Authors' Responses to the comments of Referee #1 on

"Fundamental effect of vibrational mode on vortex-induced vibration in a brimmed diffuser for a wind turbine" by Taeyoung Kim et al. (wes-2020-29)

**Figure 14. Compliance of each mode with respect to wind speed in the aeroelastic analysis**

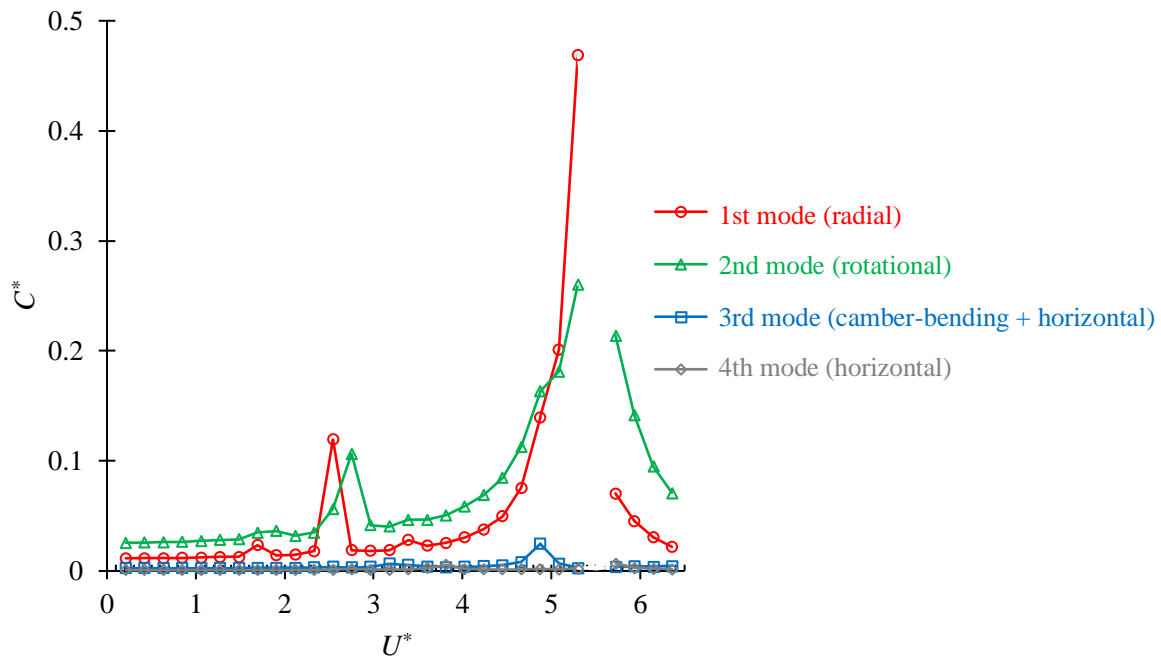
"The lock-in phenomenon deserves a more thorough discussion. Its identification in fig. 16 is not convincing."

Line 372, Page 19: The sentence, "As shown in Fig. 14, the third and fourth natural modes are excited by the weak second vortex mode only, while the responses of the first and second natural modes are noticeable because the radial and rotational modes are more sensitive to the three vortex modes.", will be replaced for the clear and concise explanation as follows.

In the current manuscript, we mentioned that we could not obtain the convergent results at $U^* = 5.1$, 5.3, and 5.5 because of the large deformation of the structure occurring in the transient response. Fortunately, we now obtained the limit-cycle oscillation results at $U^* = 5.1$ and 5.3 by gradually increasing the uniform wind speed, yet we could not obtain a convergent result at $U^* = 5.5$ because of much larger deformation in the transient response. To present the lock-in more clearly, we plan to replace Figs. 14, 15 and 16 with updated ones, as shown below. In the updated Fig. 16, we arrange the spectrum line of lift and drag at the respective velocities to accurately express the discretized data instead of the surface contour of frequency spectra in the whole calculation domain. Even if the figures are updated in the revised version, the explanations related to Figs. 14 and 15 are the same as those in the current manuscript because the tendency of the graphs is the same. Thanks to the updated figures, we will be able to add the discussion about the lock-in phenomena in more detail in the revised version.

As shown in Fig. 14, the camber-bending and horizontal modes are hard to be excited due to the higher modal stiffness, while the responses of the radial and rotational modes are noticeable because of the lower modal stiffness and the sensitivity of the vortex modes.
